1984 Corvette: Recall: Front Brake Caliper Bracket Bolt

Subject: PRODUCT SAFETY FRONT BRAKE CALIPER BRACKET BOLT

Model and Year: 1984 CHEVROLET CORVETTE MODELS (VIN: E5100001 - E5109828)

Bulletin Number: 84-C-02 - (06/01/1983)

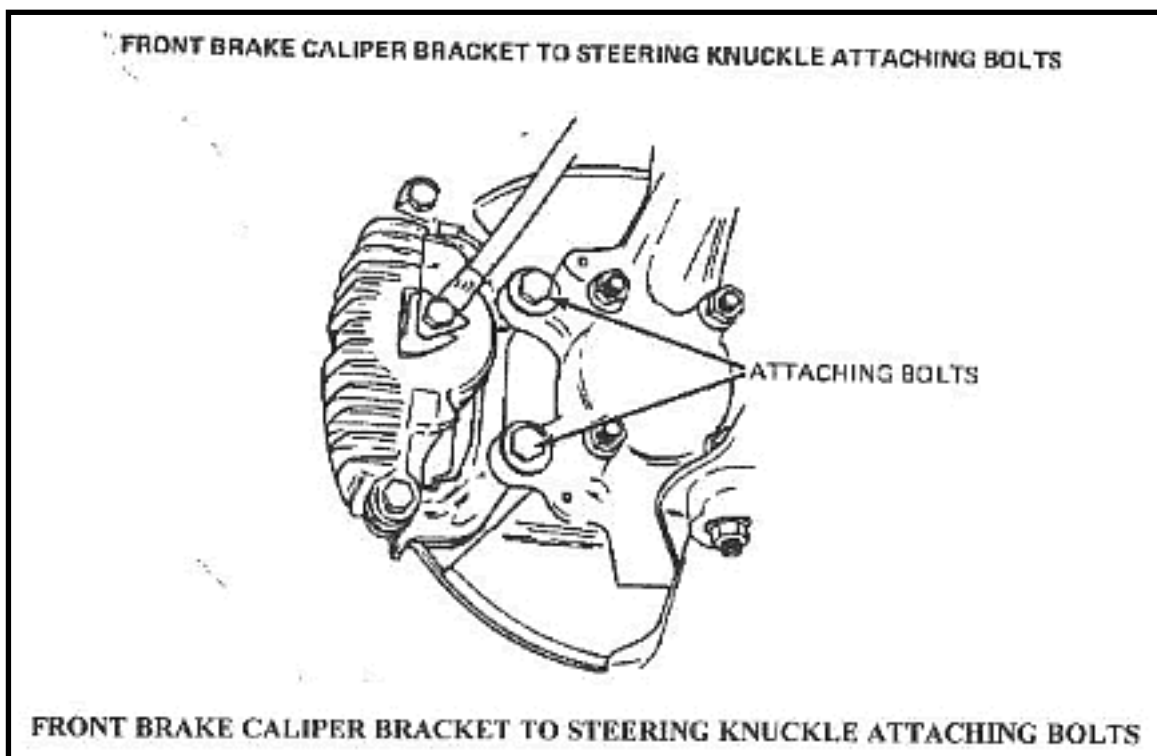
GENERAL MOTORS HAS DETERMINED THAT A DEFECT WHICH RELATES TO MOTOR VEHICLE SAFETY EXISTS IN CERTAIN EARLY PRODUCTION 1984 CORVETTES. THE FRONT BRAKE CALIPER BRACKET TO STEERING KNUCKLE ATTACHING BOLTS MAY LOOSEN AND FALL OUT. THE FRONT BRAKE CALIPER MAY THEN BECOME PARTIALLY DETACHED FROM THE KNUCKLE ASSEMBLY AND MAY CAUSE THE WHEEL TO LOCK. SHOULD THIS OCCUR WHILE THE VEHICLE IS IN MOTION, IT COULD RESULT IN A LOSS OF CONTROL, A VEHICLE CRASH COULD OCCUR WITHOUT PRIOR WARNING.

TO PREVENT THE POSSIBILITY OF THIS CONDITION OCCURRING, CHEVROLET DEALERS ARE TO REPLACE THE FRONT BRAKE CALIPER BRACKET TO STEERING KNUCKLE ATTACHING BOLTS ON ALL INVOLVED VEHICLES IN ACCORDANCE WITH THE SERVICE PROCEDURE AS OUTLINED IN THIS CAMPAIGN BULLETIN.

140799998 4 FRONT BRAKE CALIPER BRACKET TO STEERING KNUCKLE ATTACHING BOLT

IMPORTANT: THE NEW BOLT P/N 140799998 CAN BE IDENTIFIED BY THE ORANGE COLORED ADHESIVE PATCH MATERIAL ON THE BOLT THREADS.

1. RAISE HOOD.
2. REMOVE THE UPPER CALIPER ATTACHING BOLT.
3. USING THE NEW 3/8 IN. CYLINDRICAL WIRE BRUSH PROVIDED, FIRST THOROUGHLY CLEAN THE BRUSH WITH 1,1,1 TRICHLORETHANE SOLVENT; LET DRY.
4. CLEAN THREADS IN THE UPPER CALIPER ATTACHMENT BY THREADING THE BRUSH THROUGH THE THREADS AS FAR AS POSSIBLE, THEN REMOVE BY REVERSE THREADING. THIS STEP MUST BE PERFORMED TO REMOVE RESIDUAL TEFLON NO MATTER HOW CLEAN THE THREADS APPEAR.
5. BLOW OUT THREADS WITH AIR GUN.
6. INSTALL NEW BOLT PROVIDED, P/N 140799998, AND TORQUE TO 97 N.M (70 FTL.LB.).
7. REPEAT THE PROCESS FOR THE LOWER CALIPER ATTACHING BOLT.
